Serial No.:	09-084A
NLOS/WDC	R0
Docket No.:	50-423
License No.:	NPF-49

DOMINION NUCLEAR CONNECTICUT, INC.
MILLSTONE POWER STATION UNIT 3
RESPONSE TO REQUEST FOR ADDITIONAL INFORMATION REGARDING A SPENT FUEL POOL CRITICALITY LICENSE AMENDMENT REQUEST

RESPONSE TO RAI QUESTIONS 21 AND 24 REGARDING THE SPENT FUEL POOL CRITICALITY LICENSE AMENDMENT REQUEST

Figure 1: Minimum Fuel Assembly Burnup and Decay Time Versus Nominal Initial Enrichment for Region 2 Storage Configuration

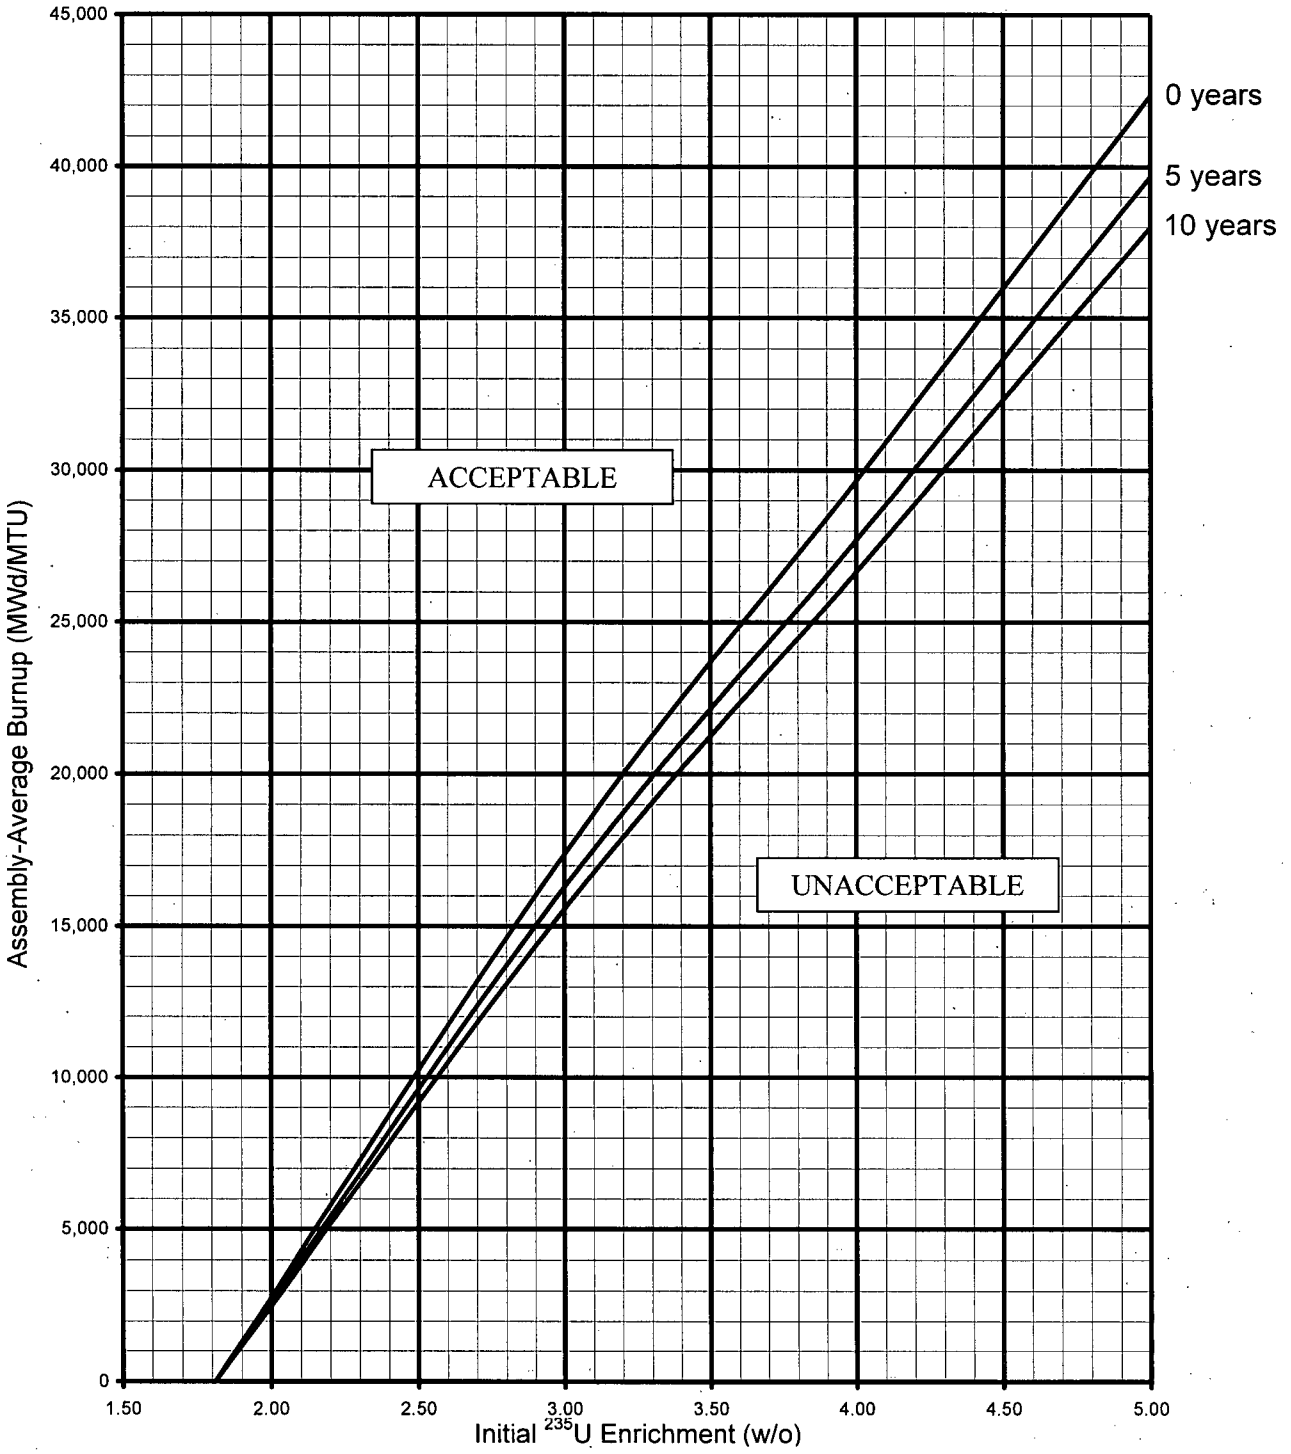
In the response to RAI 1 - 3 regarding the axial burnup distribution modeling, it is stated that Profile 5 from NUREG/CR 6801, "Recommendations for Addressing Axial Burnup in PWR Burnup Credit Analyses," March 2003, was used. In NUREG/CR-6801, Figures 3 and 7 - 18 show various profile shapes at various burnup intervals. Additionally, Figures 19 - 30 statistically demonstrate the bounding profile for various burnup intervals. Demonstrate Profile 5 is bounding for all MPS3 fuel axial burnup profiles, in particular the 15-25 gigawatt day per metric ton uranium (GWd/MTU) range.

Based on the results provided, non-conservatisms have been identified in the originally submitted WCAP curves for Region II and Region III minimum fuel burnup at various points on the curve. The proposed Region II and III burnup curves will be modified to offset the above identified non-conservatism.

Based on the results in Table 21-6, the Region II required fuel burnups at 3 w/o and 4 w/o U235 at all decay times are increased by 0.5 GWd/MTU. Based on the results in Table 21-6, the Region III required fuel burnups at 3 w/o U235 at all decay times are increased by 1.5 GWd/MTU.

To implement this restriction of no future use of No Blanket fuel at MPS3, a footnote will be added to proposed Technical Specification Figure 3.9-3 for Region II fuel storage, and Figure 3-9-5 for Region III for storage of Post-Uprate fuel. Figures 1 and 2 show this footnote.

The proposed revised tabular values for the Region II and Region III burnup/enrichment limits are provided in Table 21-7 (Region II) and Table 21-8 (Region III). These are plotted in Figures 1 (Region II) and 2 (Region III).

NOTE: For assemblies from Post-Uprate (3650 MWt) Cores, the nominal fuel enrichment of blankets must be ≤ 2.6 w/o U-235, and nominal blanket length must be at least 6 inches on both ends of the fuel.

Figure 3.9-3 Minimum Fuel Assembly Burnup and Decay Time Versus Nominal Initial Enrichment for Region 2 Storage Configuration

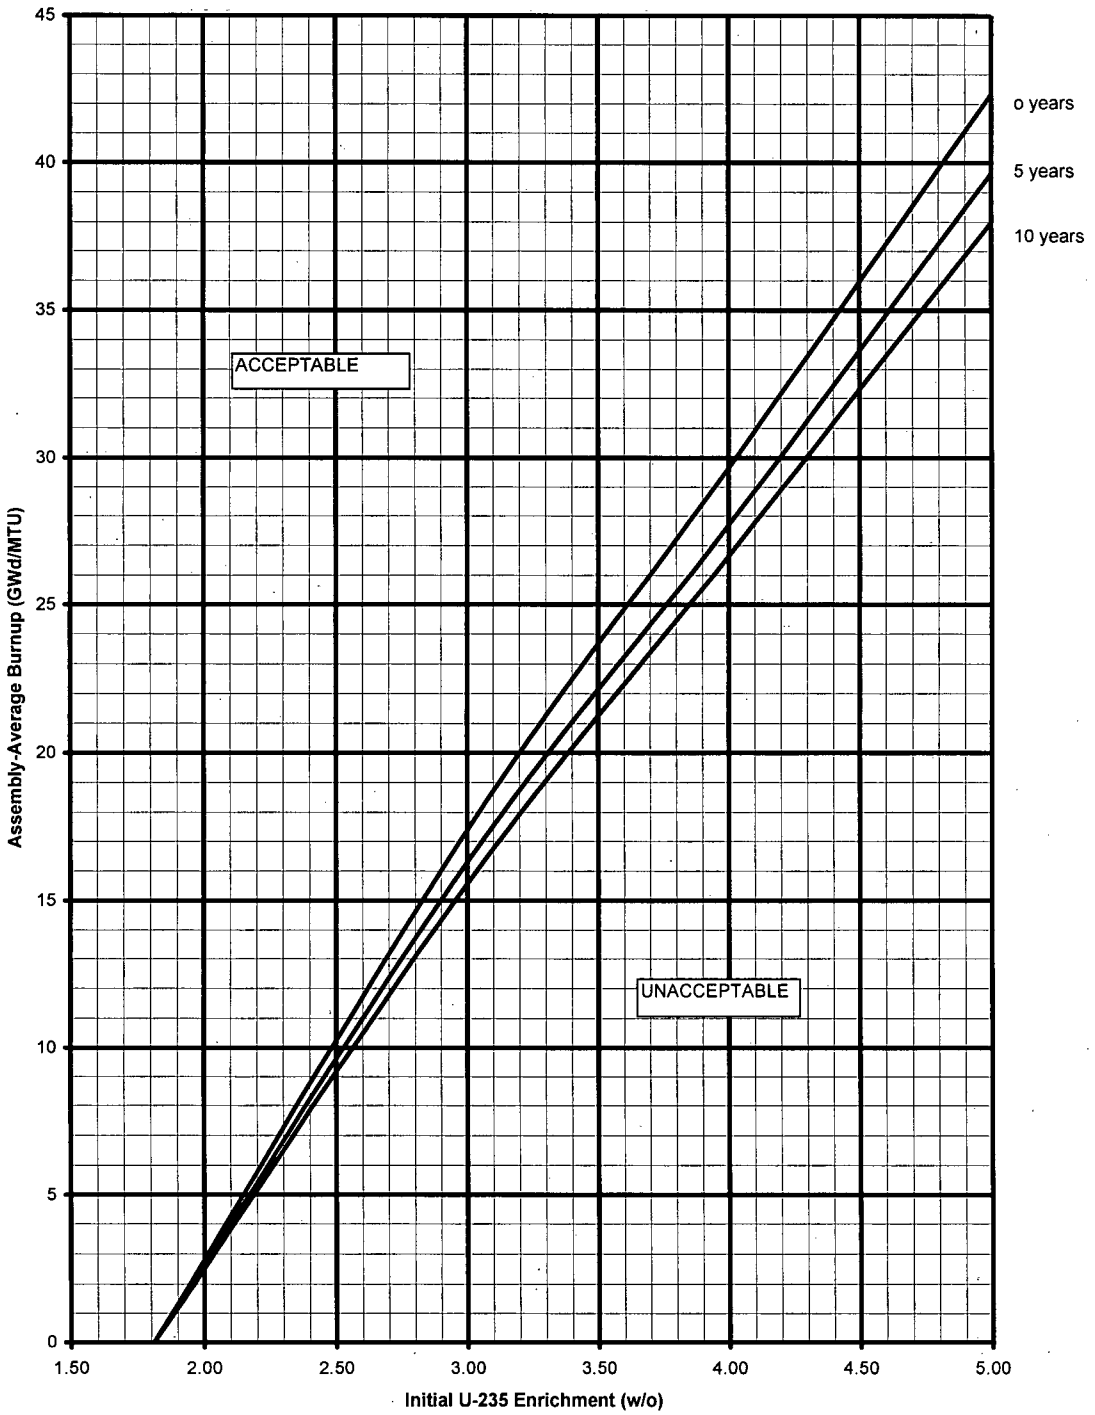
Attachment 1 contains the responses to RAI questions 21 and 24. The information in Figure 1 and Figure 2 in the response to RAI question 24 is used to update the information provided in DNC letter dated July 13, 2007 (ADAMS No. ML072000386), Attachment 3, "Mark-up of The Operating License and Technical Specifications Pages," Figure 3.9-3 and Figure 3.9-5. The updated Figure 3.9-3 and Figure 3.9-5 are provided in Attachment 2.

NOTE: For assemblies from Post-Uprate (3650 MWt) Cores, the nominal fuel enrichment of blankets must be ≤ 2.6 w/o U-235, and nominal blanket length must be at least 6 inches on both ends of the fuel.
